Service Bulletin No: 91-001
Modification No: EC-19-0553

**AIR VEHICLE WIRING - GENERAL
IMPROVEMENTS TO THE AIRCRAFT ELECTRICAL HARNESS INSTALLATION**

PC-24 aircraft MSN 101 thru MSN 160.

To improve the electrical harness installation, at various locations throughout the aircraft, to prevent the possibility of the electrical harness chafing on the structure and/or moving parts.

Improvements to the electrical harness installation - Cockpit
Figure 2 (Sheet 5 of 6)

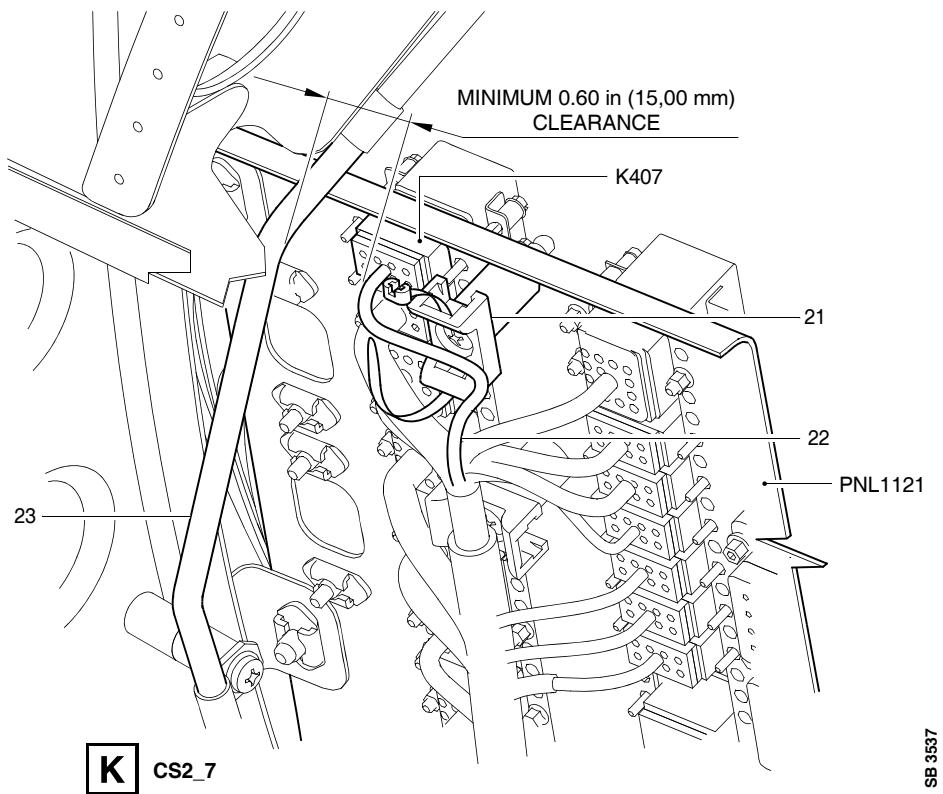
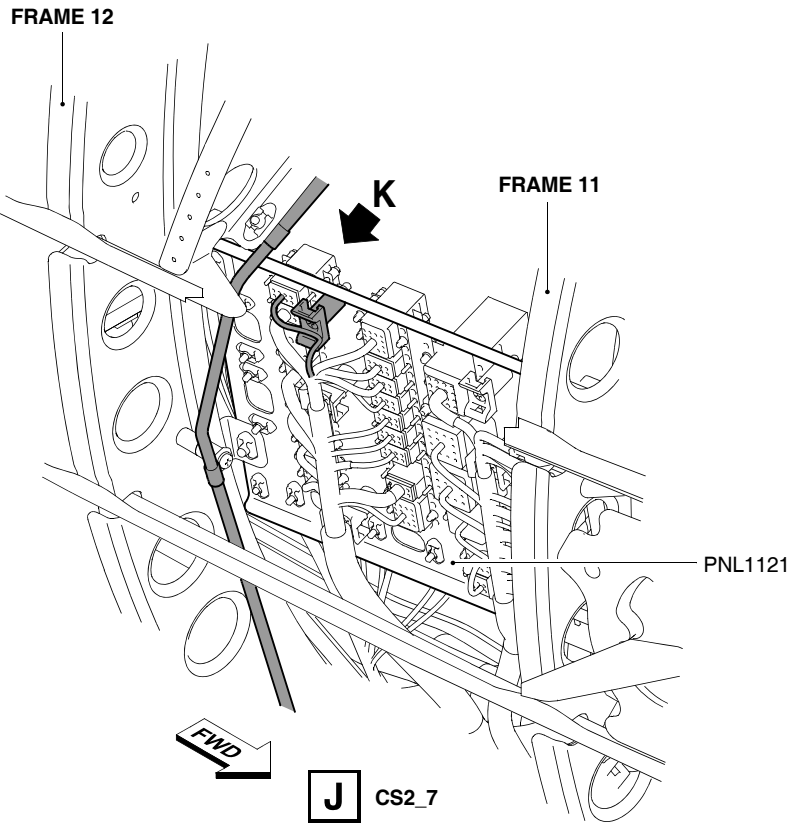
On the LH side of the cockpit, at the rear of the pilots Electronic Standby Instrument System (ESIS):

- (a) Cut and remove the necessary cable ties from the electrical harness (19) to get sufficient access to install the new protection sleeve (20).
- (b) Cut a new piece of protection sleeve (20) (P/N 917.96.92.154) to a length of 3.94 in (100,00 mm).

- (c) Put the new protection sleeve (20) in position on the electrical harness (19). Make sure that it is positioned so that the electrical harness (19) cannot chafe on the static pipe.
- (d) Use the applicable new cable ties (Material No. P09-005/P09-008/P09-014) to:
- Attach the protection sleeve (20) to the electrical harness (19)
 - Replace any cable ties that you cut and removed to get access.
- (4) **Improvement to prevent the electrical harness from chafing on the hydraulic pipe. Refer to Figure 2 (Sheet 6)**

Improvements to the electrical harness installation - Cockpit
Figure 2 (Sheet 6 of 6)

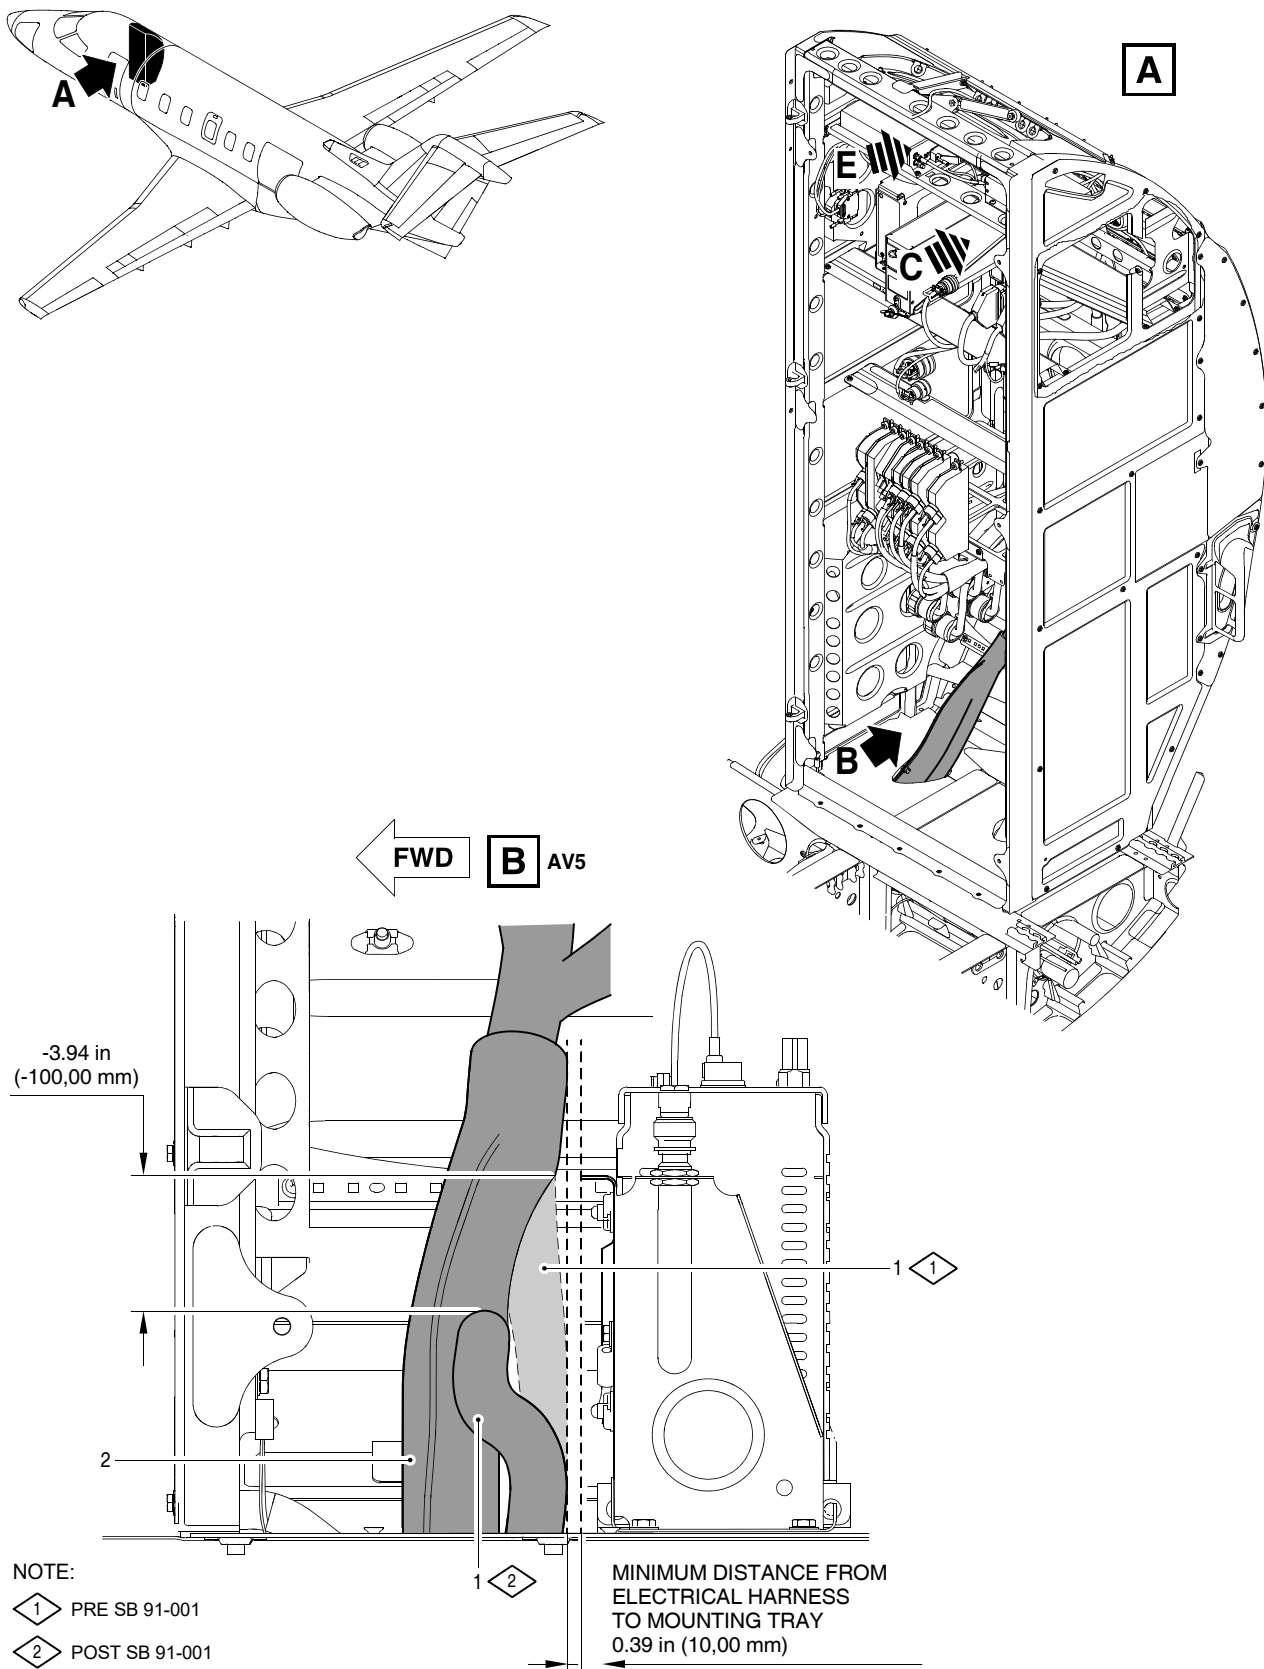
On the RH side of the cockpit, aft of Frame 11, at the electrical harness that is connected to relay K407 at the rear of the copilots equipment panel (PNL1121):

- (a) Do a check to see if the distance from the electrical harness (22) to the hydraulic pipe (23) is ≥ 0.60 in (15,00 mm).
- (b) If the distance from the electrical harness (22) to the hydraulic pipe (23) is < 0.60 in (15,00 mm):
- 1 Cut and remove the necessary cable tie(s) so that you can modify the route of the electrical harness (22).
 - 2 Modify the route so that the:
 - Electrical harness (22) can be attached to the saddle (21)
 - Clearance from the hydraulic pipe (23) is a minimum distance of 0.60 in (15,00 mm).
 - 3 Put new tape (Silicone red, fiberglass) (Material No. P09-064) around the electrical harness (22) at the new installation position on the saddle (21).

- 4 Use the applicable new cable ties (Material No. P09-005/P09-008/P09-014) to:
- Attach the electrical harness (22) on the saddle (21)
 - Replace any cable ties that you cut and removed to get access.

Improvements to the electrical harness installation - Avionics rack
Figure 3 (Sheet 1 of 4)

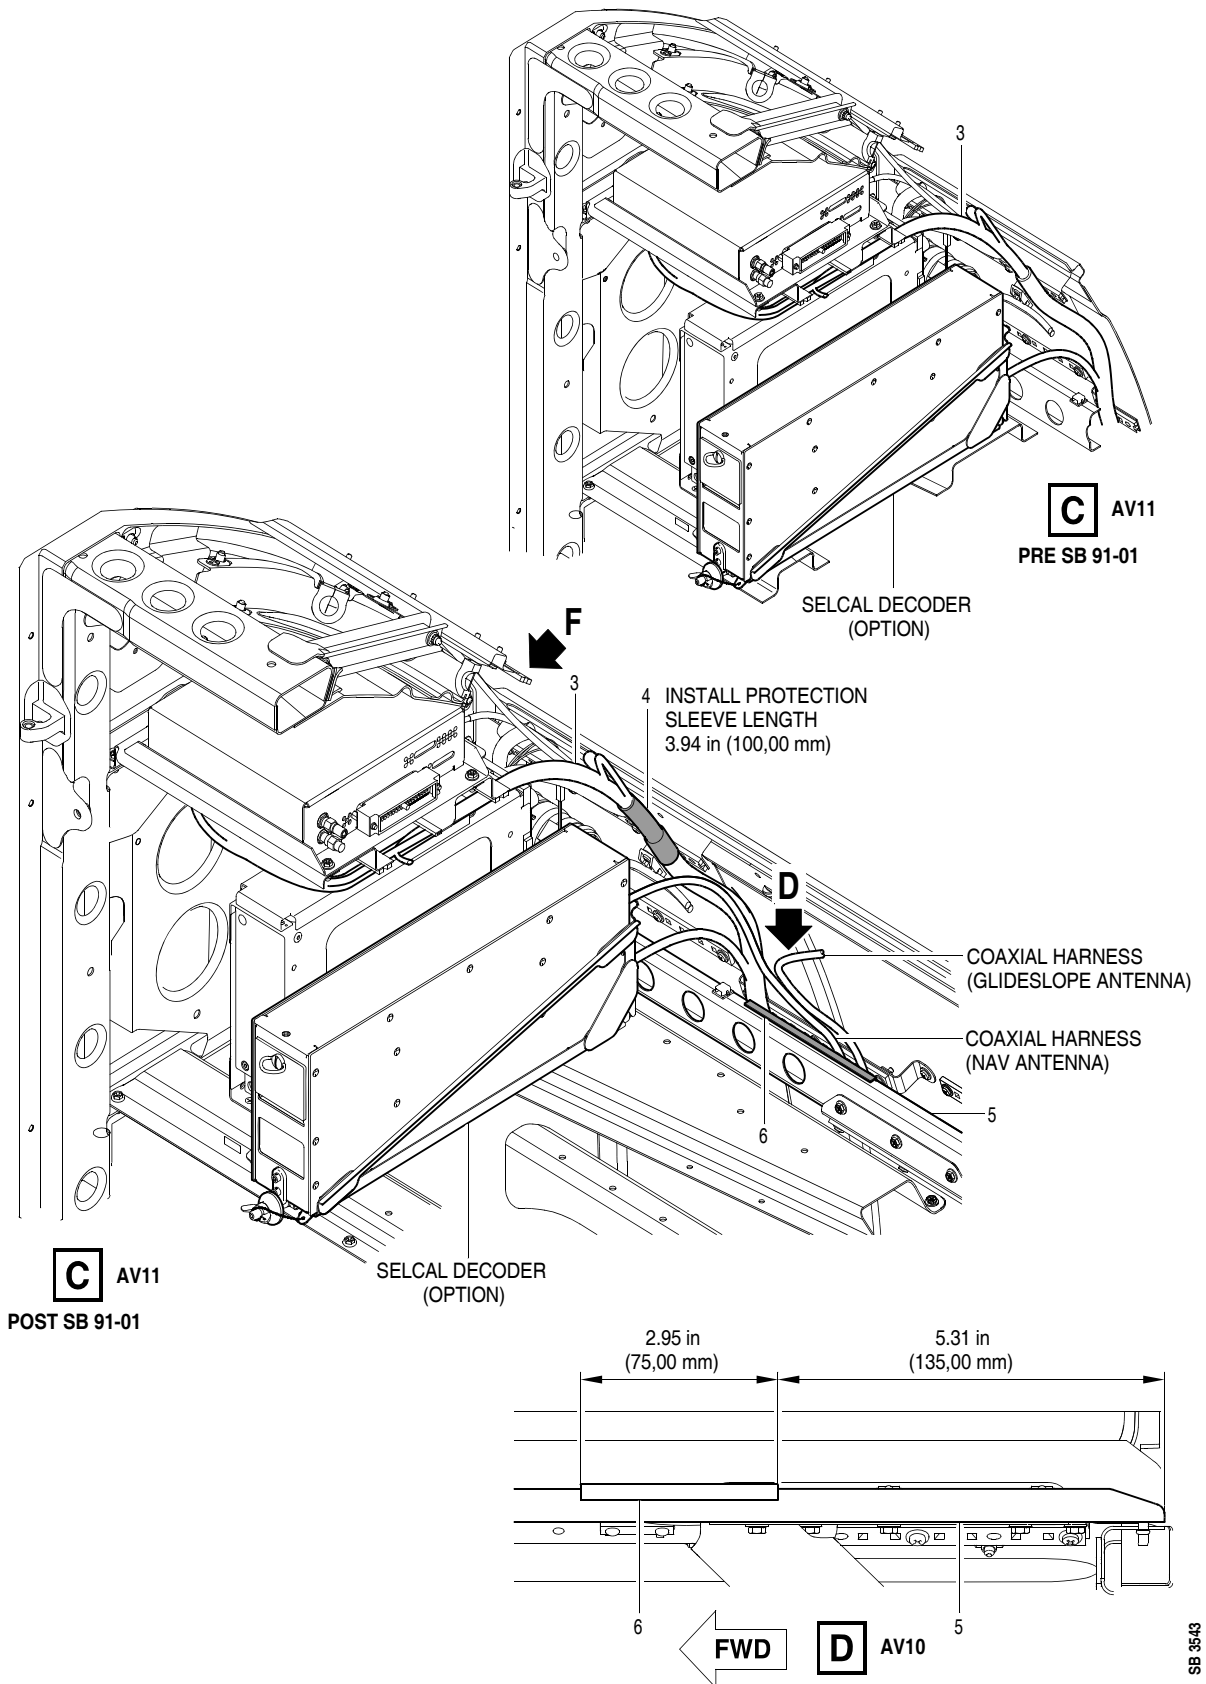
- (1) Improvement to prevent the electrical harness from chafing on the mounting tray. Refer to Figure 3 (Sheet 1)**

At the bottom of the avionics rack, where the emissive harness and the susceptible harness branch-out at the side of the mounting tray for the entertainment system:

- (a) Cut and remove the necessary cable ties from the emissive harness (2) and the susceptible harness (1) so that you can route the branch-out to the new position.

NOTE: The new position for the branch-out is 3.94 in (100,00 mm) below the existing position.

- (b) Remove/Install tape (Silicone red, fiberglass) (Material No. P09-064), as necessary, when you modify the route of the branch-out.
- (c) Use the applicable new cable ties (Material No. P09-005/P09-008/P09-014) to:
- Route the susceptible harness (1) and the emissive harness (2) so that the branch-out is 3.94 in (100,00 mm) below the original position. Refer to Figure 3 (Sheet 1, View B)
 - Route the susceptible harness (1) and the emissive harness (2) so that there is a minimum distance of 0.39 in (10,00 mm) from the mounting tray of the entertainment system. Refer to Figure 3 (Sheet 1, View B)
 - Replace any cable ties that you cut and removed.

Improvements to the electrical harness installation - Avionics rack
Figure 3 (Sheet 2 of 4)

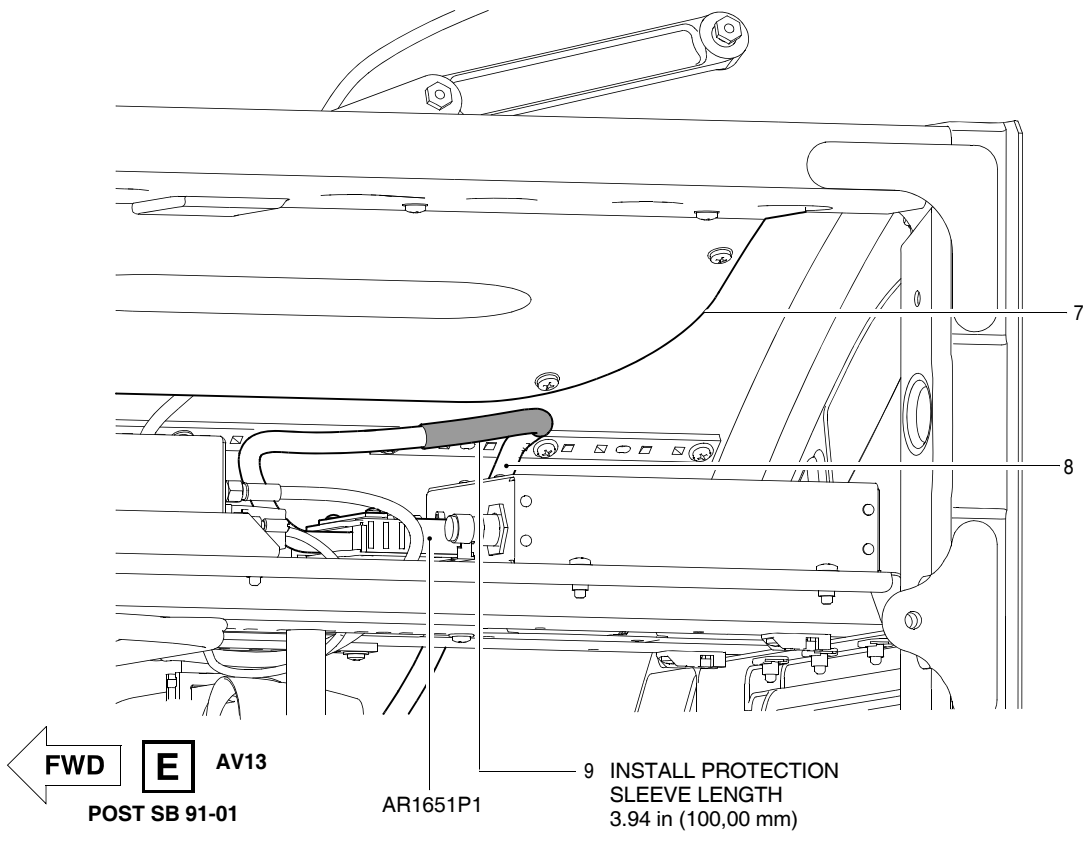
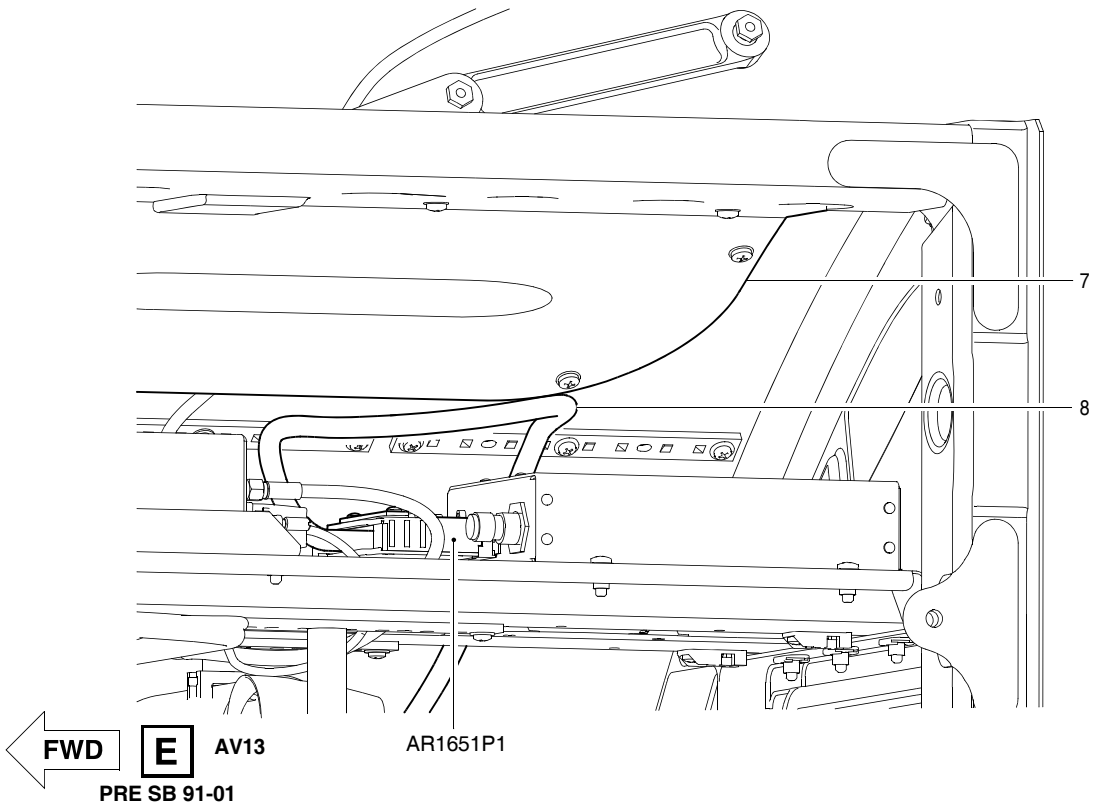
- (2) Improvement to prevent the coaxial harnesses from chafing on the avionics rack structure. Refer to Figure 3 (Sheet 2)

- (3) Improvement to prevent the electrical harness from chafing on the SELCAL decoder. Refer to Figure 3 (Sheet 2)

At the rear of the avionics rack, on the electrical harness behind the SELCAL decoder:

- (a) Cut a new piece of rubber u-section (6) (P/N 917.59.37.536) to a length of 2.95 in (75,00 mm).
- (b) Use absorbent paper (Material No. P02-031) made moist with solvent (Material No. P01-010) and clean the mating surfaces of the upper mounting rail (5).
- (c) Let the solvent dry.
- (d) Apply a layer of adhesive (Material No. P08-080) to the mating surfaces of the upper mounting rail (5).
- (e) Put the rubber u-section (6) in position on the upper mounting rail (5).
- (f) Remove unwanted adhesive with absorbent paper (Material No. P02-031) made moist with solvent (Material No. P01-010).

- (a) Cut and remove the necessary cable ties from the electrical harness (3) to get sufficient access to install the new protection sleeve (4).
- (b) Cut a new piece of protection sleeve (4) (P/N 917.96.92.154) to a length of 3.94 in (100,00 mm).
- (c) Put the new protection sleeve (4) in position on the electrical harness (3). Make sure that it is positioned so that the electrical harness (3) cannot chafe on the SELCAL decoder.
- (d) Use the applicable new cable ties (Material No. P09-005/P09-008/P09-014) to:
 - Attach the protection sleeve (4) to the electrical harness (3)
 - Replace any cable ties that you cut and removed to get access.

Improvements to the electrical harness installation - Avionics rack
Figure 3 (Sheet 3 of 4)

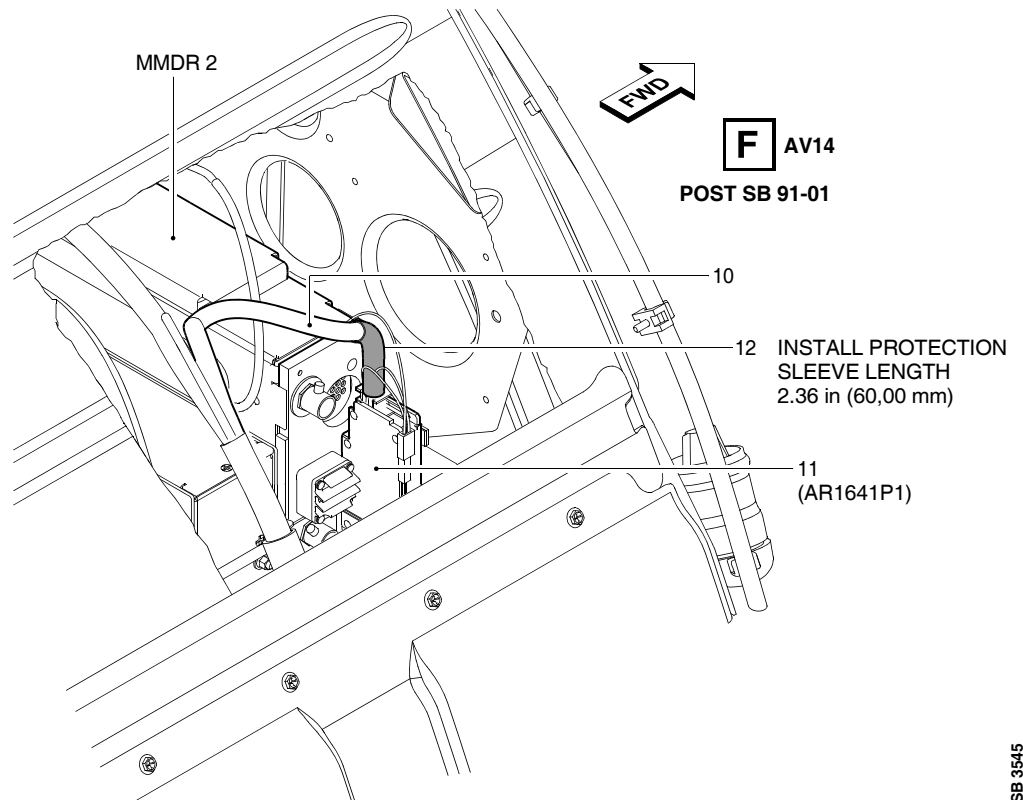
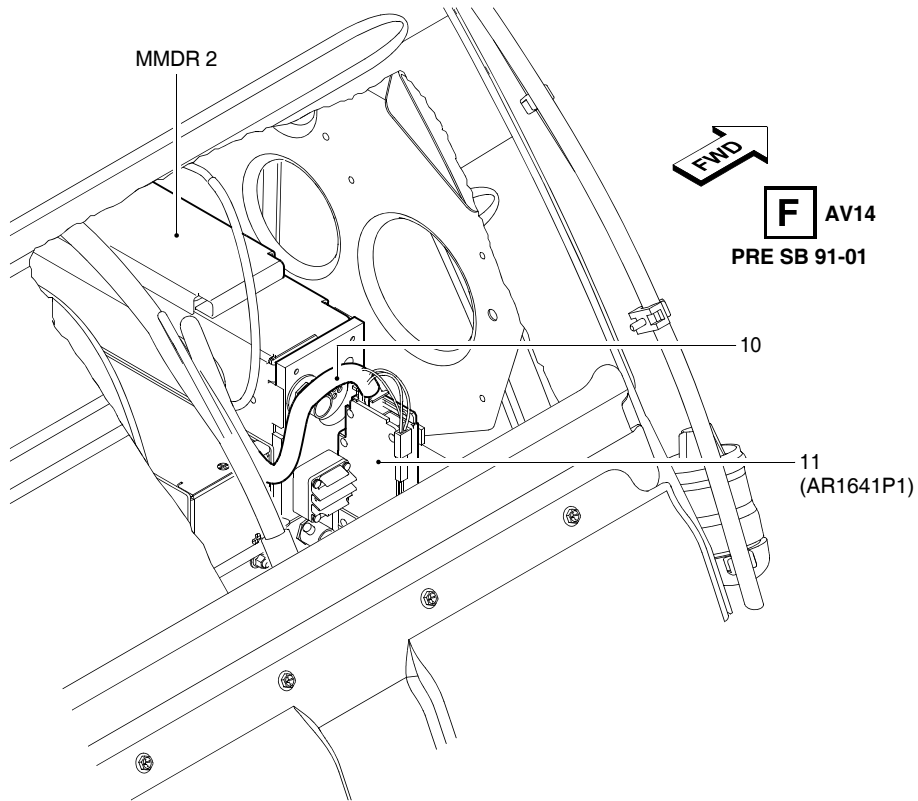
- (4) Improvement to prevent the electrical harness from chafing on the top cover of the avionics rack. Refer to Figure 3 (Sheet 3)

At the top of the avionics rack, below the top cover, on the electrical harness that comes from the electrical connector (AR1651P1):

- NOTE:** Refer to Figure 3 (Sheet 3, View E) to determine the installation position and length of the protection sleeve.
- (a) Cut and remove the necessary cable ties from the electrical harness (8) to get sufficient access to:

- Modify the route of the electrical harness (8)
 - Install the new protection sleeve (9).
- (b) Remove/Install tape (Silicone red, fiberglass) (Material No. P09-064), as necessary, when you modify the route of the electrical harness (8).
